ADDENDUM NO.: TWO

RENOVATIONS FOR MOUNTAIN VIEW PRIMARY SCHOOL ALBEMARLE COUNTY PUBLIC SCHOOLS

2026-IFB-1012182
RRMM Project No. 24191-01

This Addendum forms a part of the Construction Documents and modifies the original bidding documents dated November 6, 2025.

SHEET
AD101

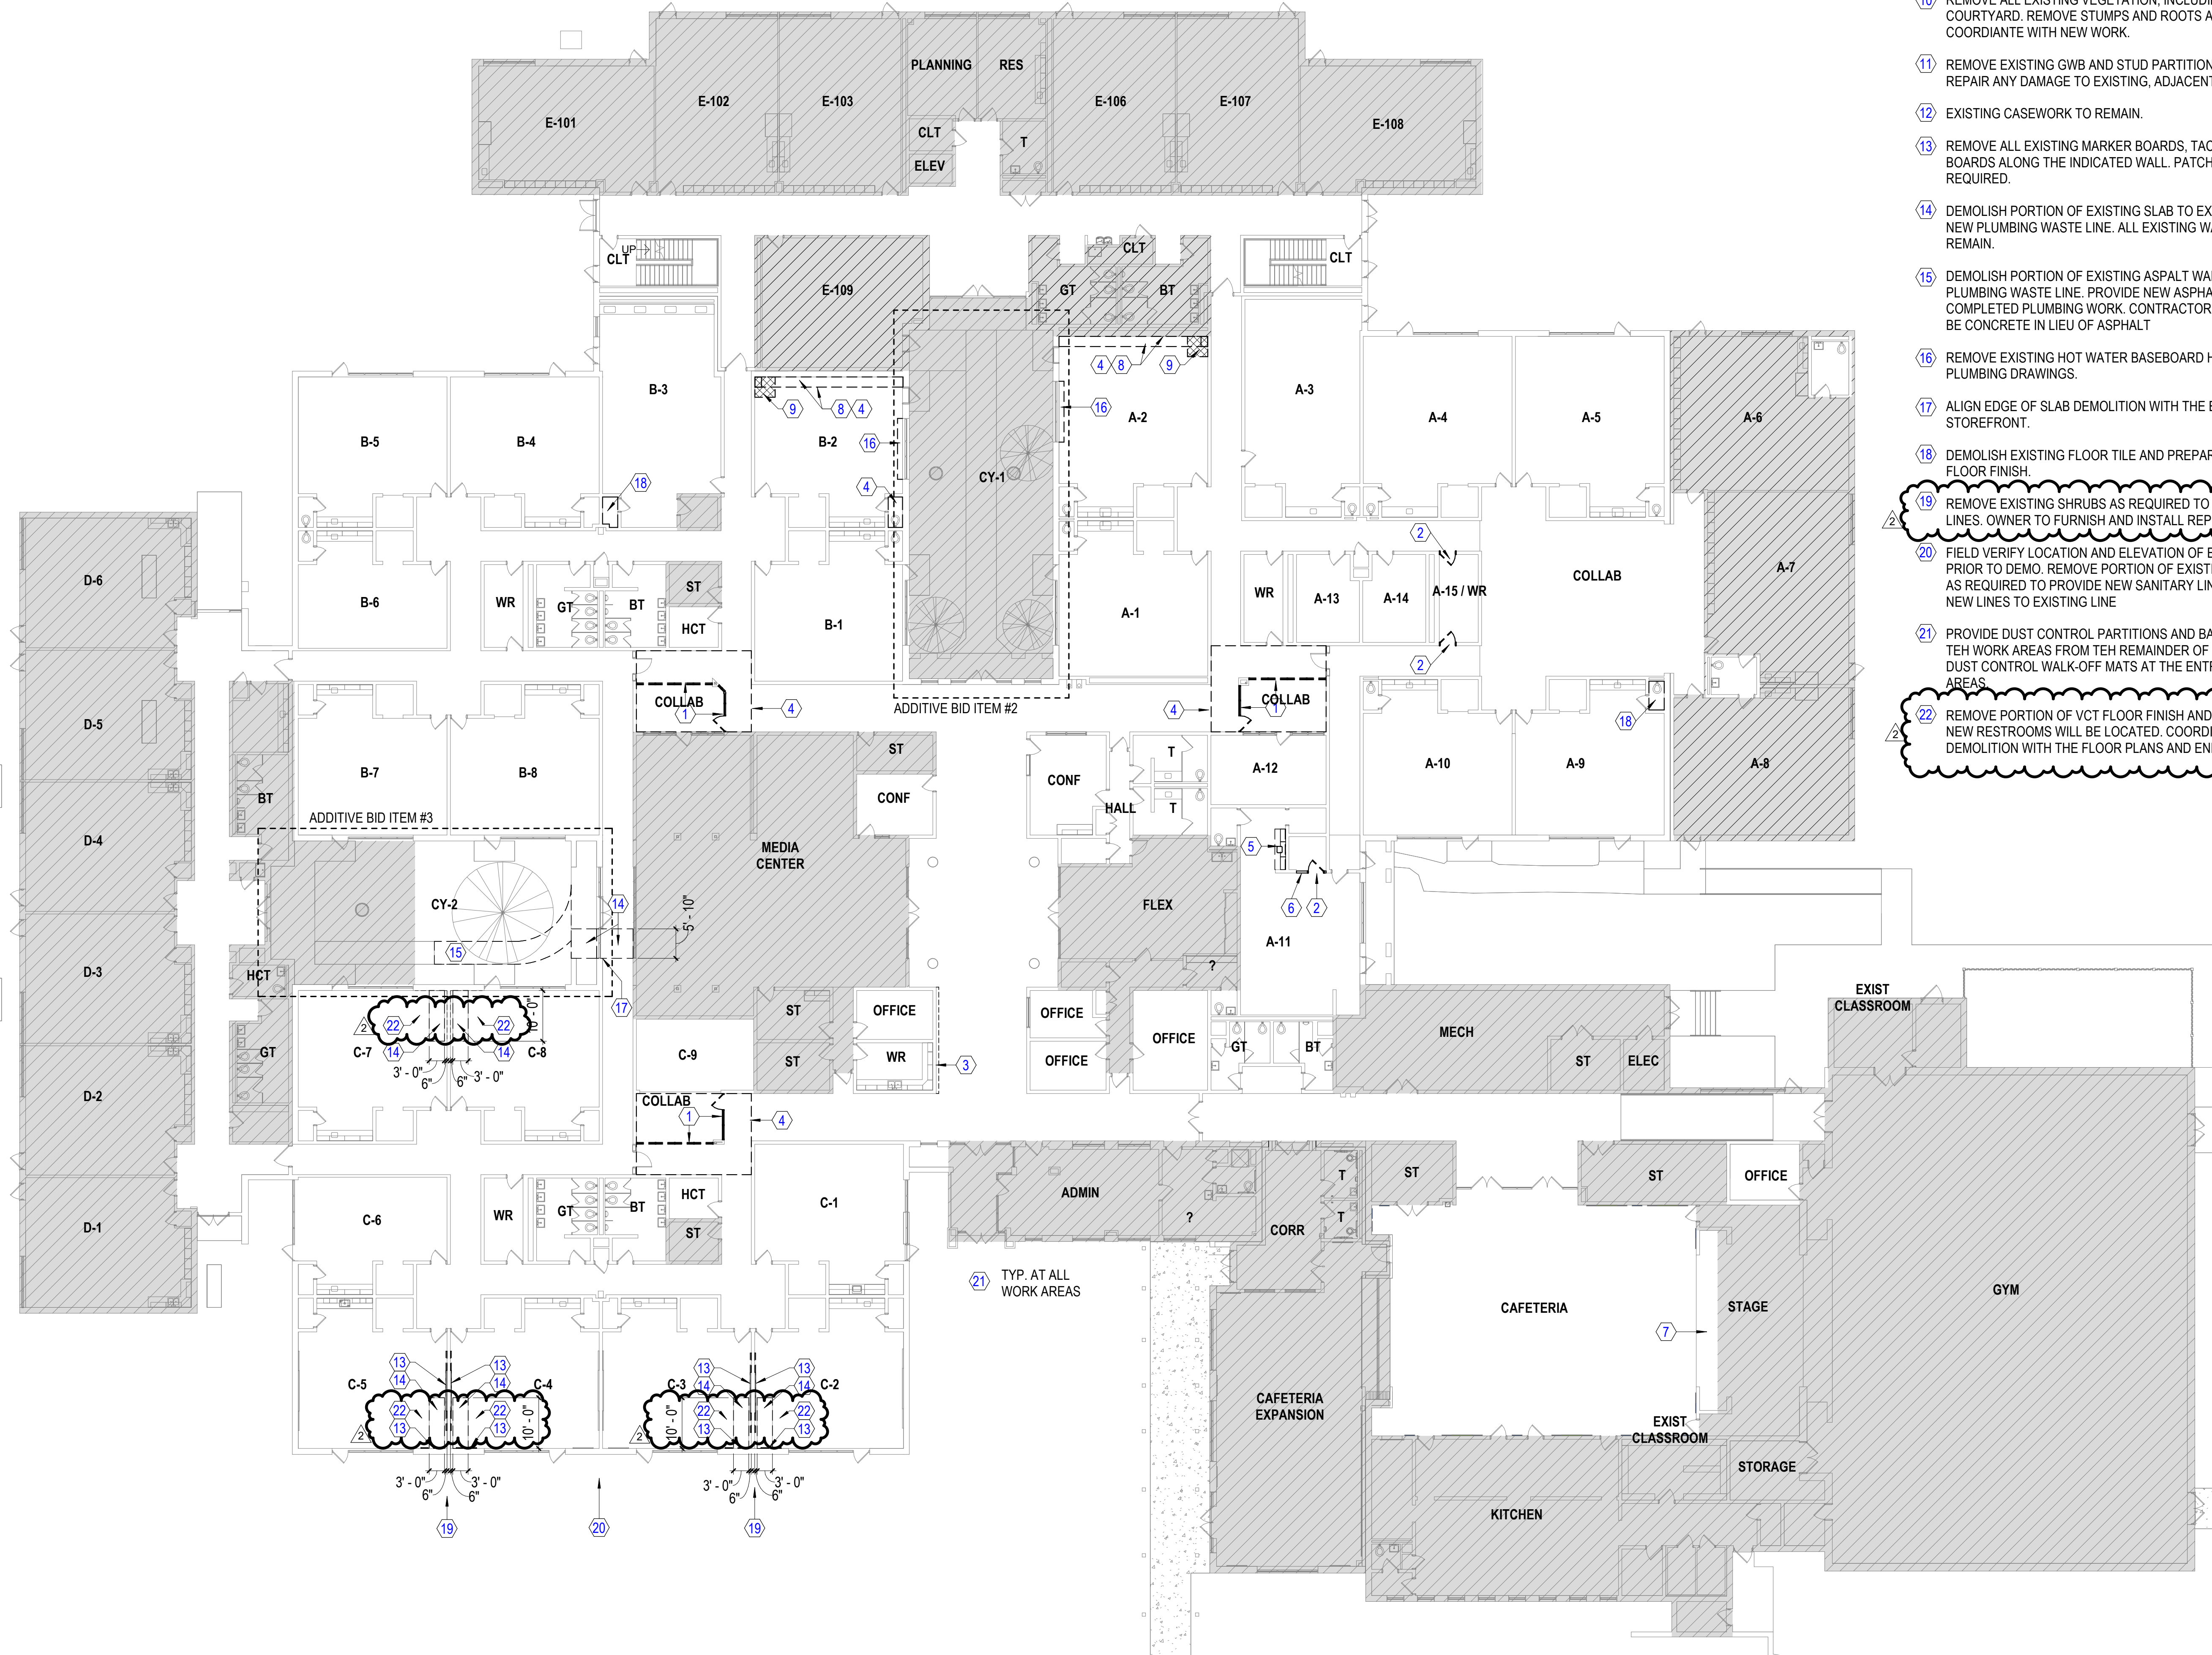
- 1.2 SHEET AD101
CLARIFY: Keynote “19” REVISED for clarity. Owner to furnish and install new shrubs.
ADD: New Keynote “22” added for clarity. Keynote 4 in rooms C-2, C-3, C-4, C-5, C-7, and C-8 changed to keynote 22.
- 1.3 SHEET A-102
REVISE: Keynote “4” text was REVISED to replaced “certified” with “licensed and authorized”.
- 1.4 SHEET A-410
ADD: At Interior Elevation D1: Operable partition dimensions and notes have been revised to reflect existing conditions and approximate partition length.

- 1.5 PRE-BID QUESTION: Plans A-601 (Finish Schedule) has Classrooms C-2, C-3, C-4, C-5, C-7, and C-8 flooring as existing to remain with only the base on two walls getting replaced. Plan AD-101 shows above classrooms to have VCT removed and replaced in 3ft x 10ft areas of classrooms (Demo Key #4). Please Clarify.

- 1.13 PRE-BID QUESTION: Demo Key Note 19/AD101 – Is the intent of ‘provide’ in this note for the Owner to furnish the shrubs to be installed by others?

- 1.14 PRE-BID QUESTION: Demo Key Note 20/AD101 – Please provide acceptable methods for field verification of existing sanitary line

Response: Refer to added Key Note 22 on AD-101 for clarification. A Portion of the existing VCT flooring and resilient base will be demolished where the new restrooms will be located to accommodate

Response: Owner shall furnish and install shrubs. See revised Key Note 19 on AD101.

Response: Field verification via excavation or “pot holing” is acceptable; no sensitive landscaping is located in the area.

- 18 DEMOLISH EXISTING FLOOR TILE AND PREPARE TO RECEIVE NEW FLOOR FINISH.
- 19 REMOVE EXISTING SHRUBS AS REQUIRED TO PROVIDE NEW SANITARY LINES. OWNER TO FURNISH AND INSTALL REPLACEMENT SHRUBS.

- 22 REMOVE PORTION OF VCT FLOOR FINISH AND RESILIENT BASE WHERE NEW RESTROOMS WILL BE LOCATED. COORDINATE EXTENT OF DEMOLITION WITH THE FLOOR PLANS AND ENLARGED TOILET PLANS.

D1 INT ELEV - CAFETERIA EAST
A-410 SCALE: 1/4" = 1'-0"

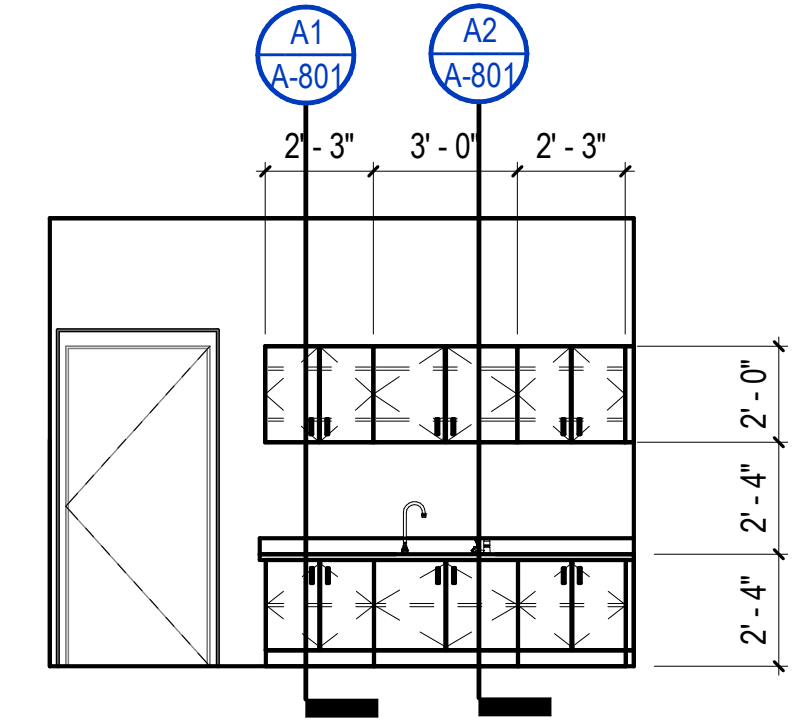
- 1.20 PRE-BID QUESTION: D1/A410 – Please confirm the number of panels in the existing operable partition to be re-surfaced. The drawings show six (6) panels however a site photo shows a possible conflicting panel count.

Response: D1/A-410 has been revised to reflect existing conditions.

A-801

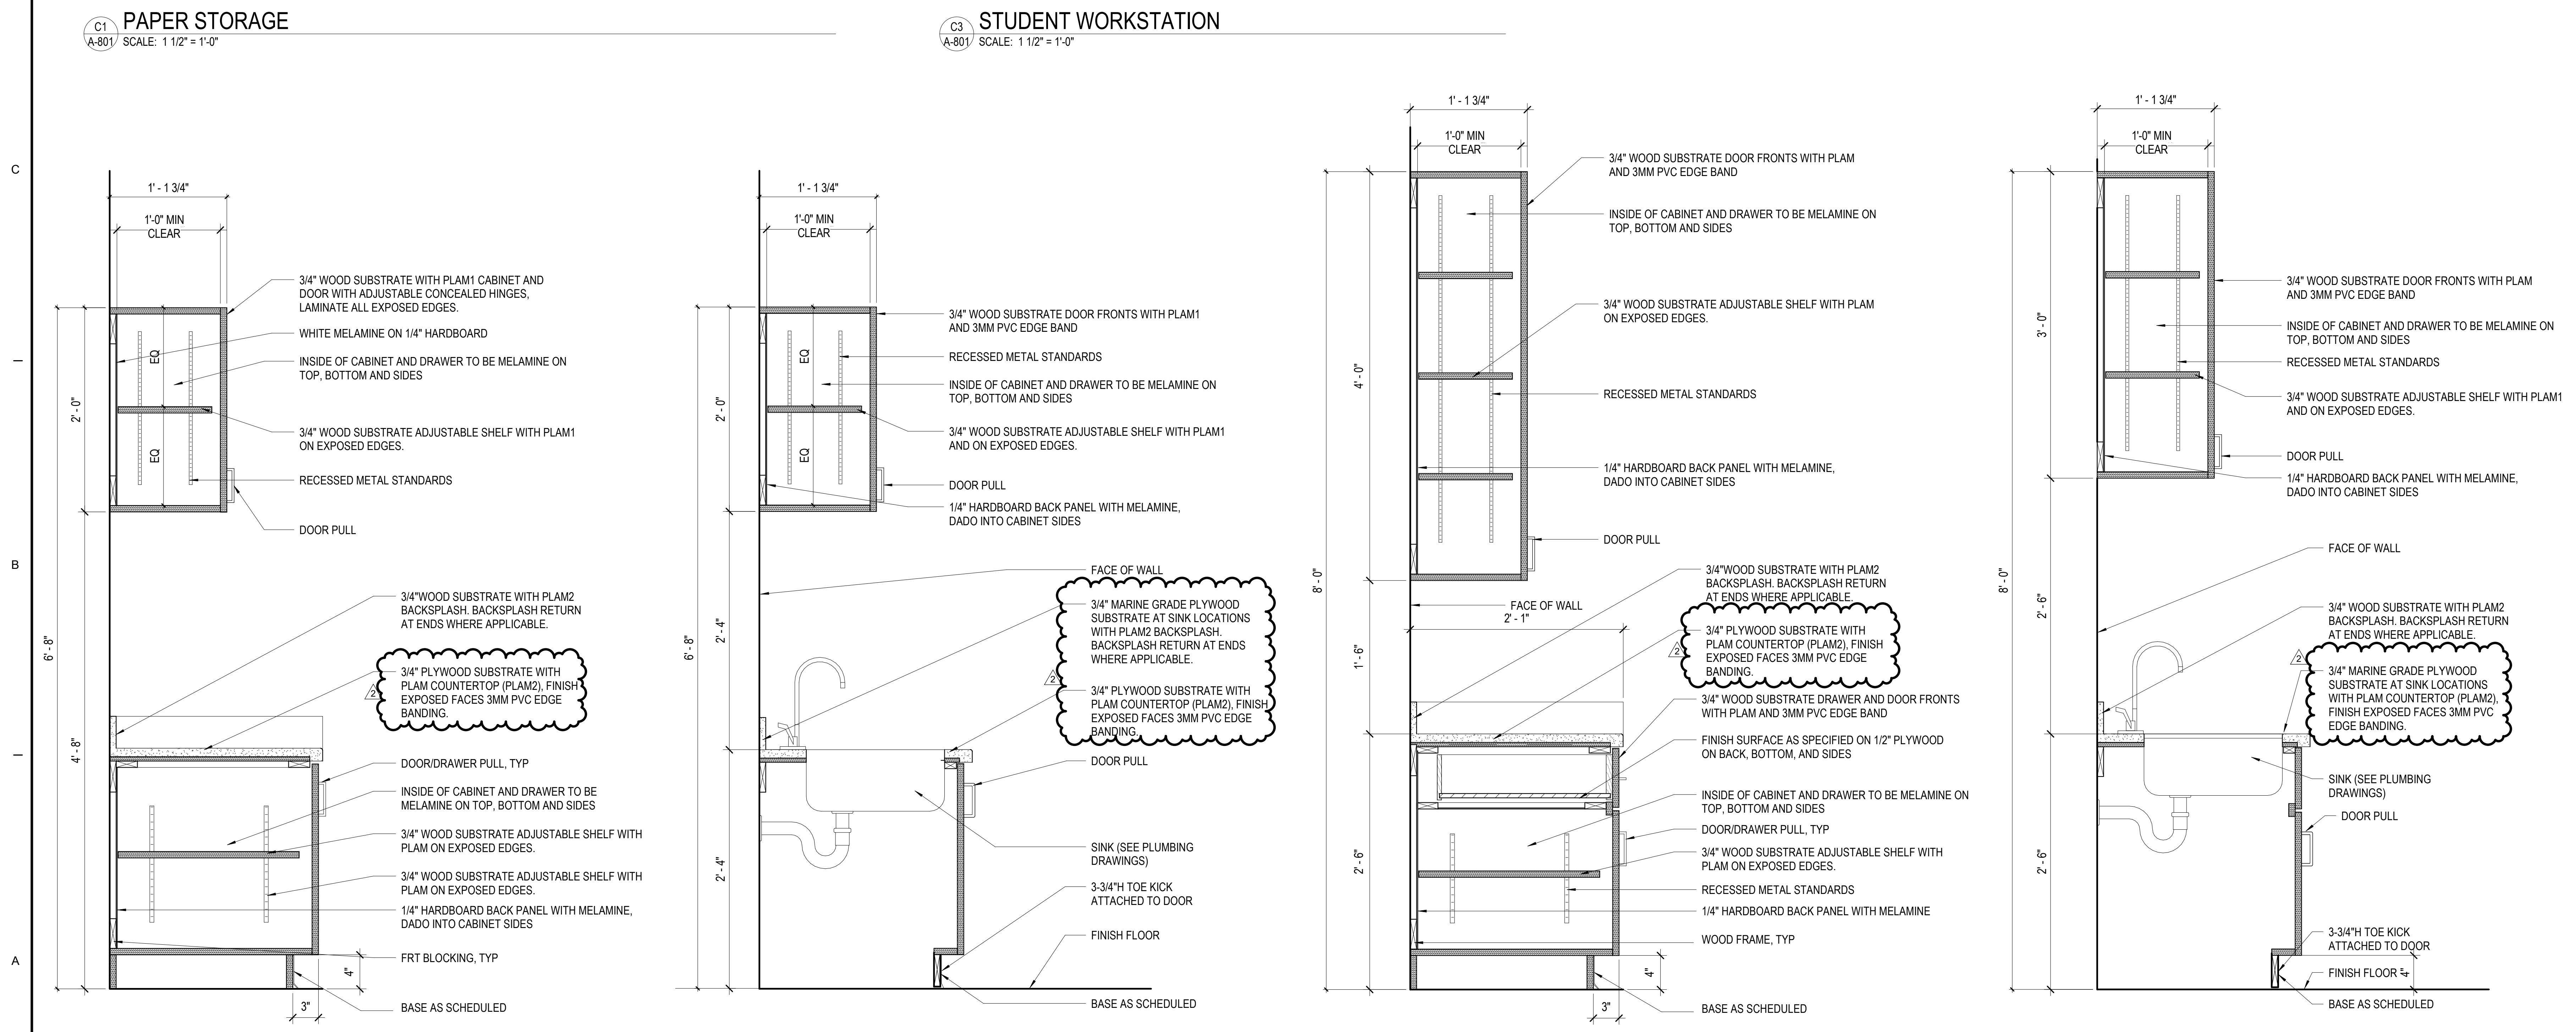
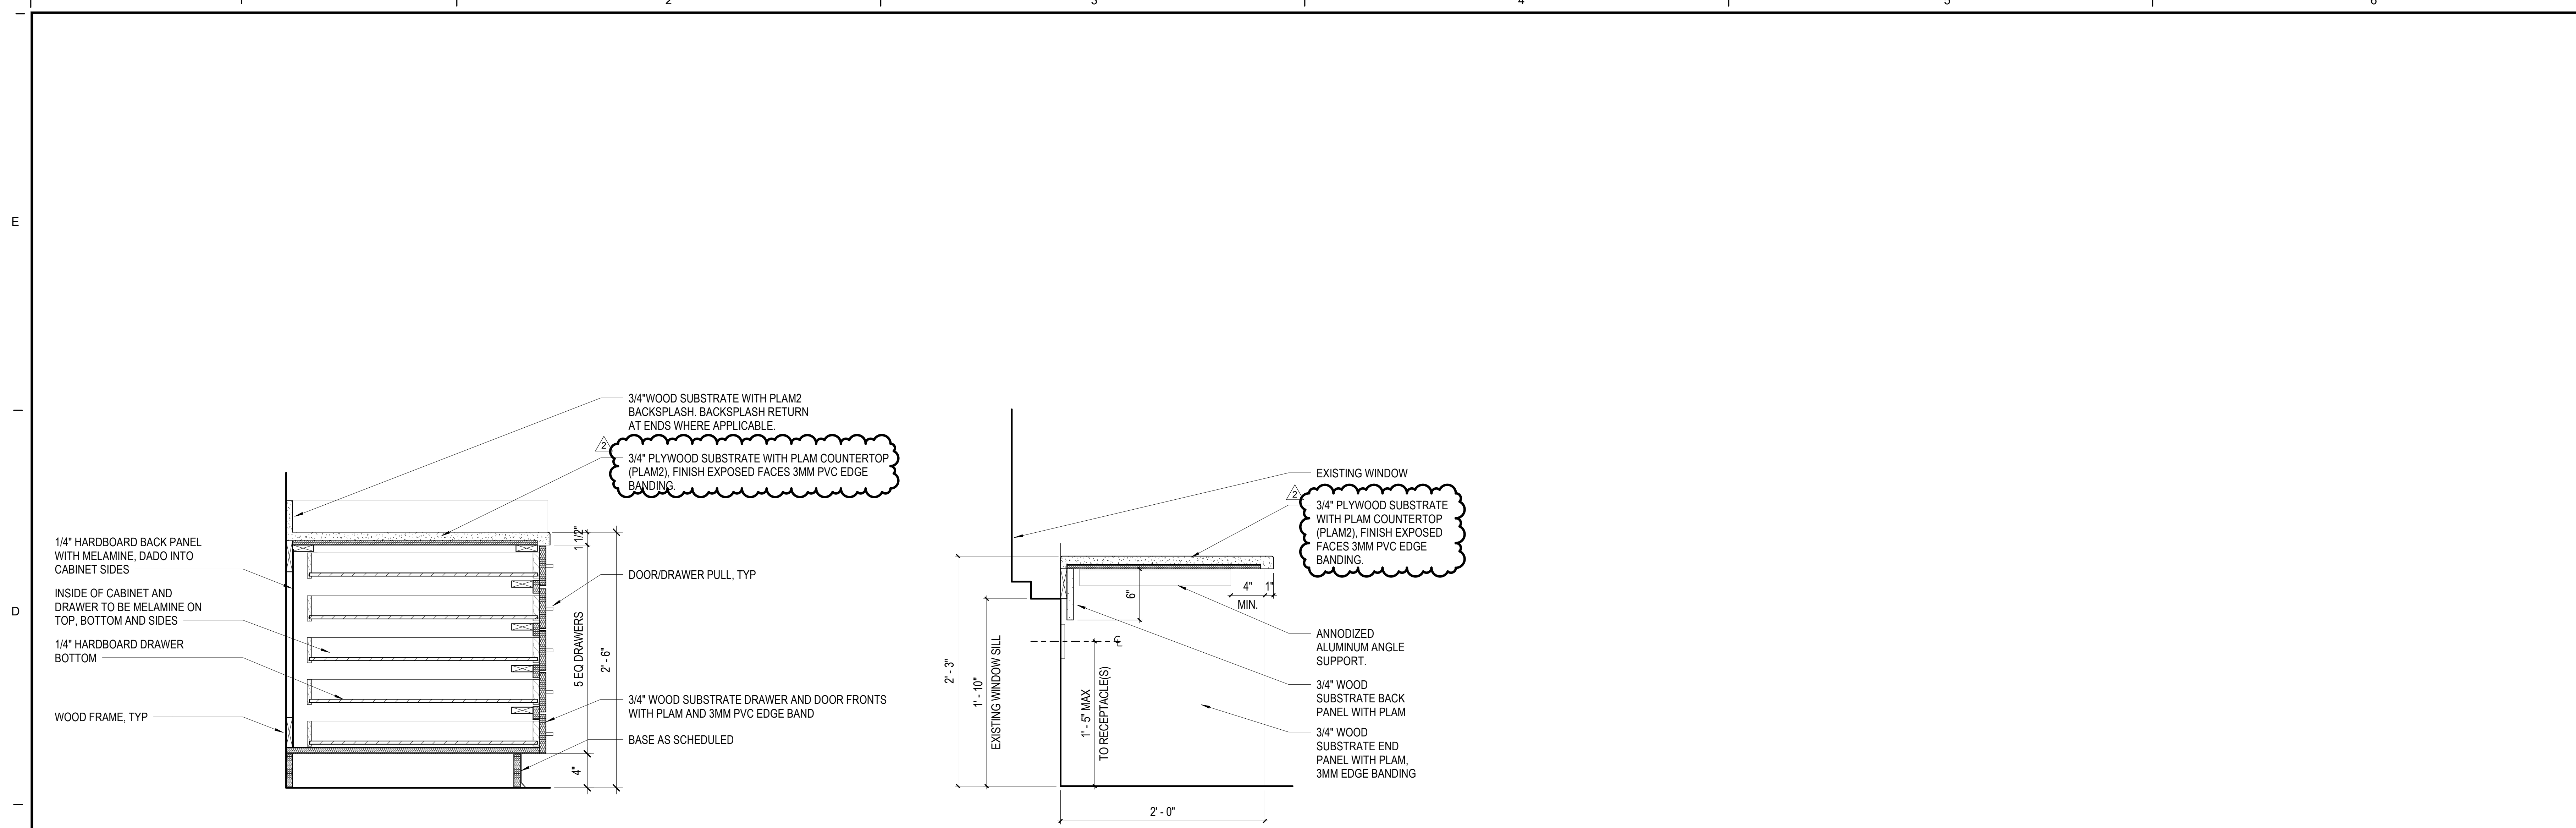
- 1.26 PRE-BID QUESTION: 064116 – Please clarify what cores are required for the cabinets and countertops. MDF, particleboard, or plywood.

Response: On sheet A-801, Wood Substrate for countertops and splashes shall be Softwood Plywood. On sheet A-801, Wood Substrate for cabinet bodies, cabinet drawers and cabinet doors shall be MDF or Softwood Plywood. See Specification Section 064116, paragraph 2.2.B.
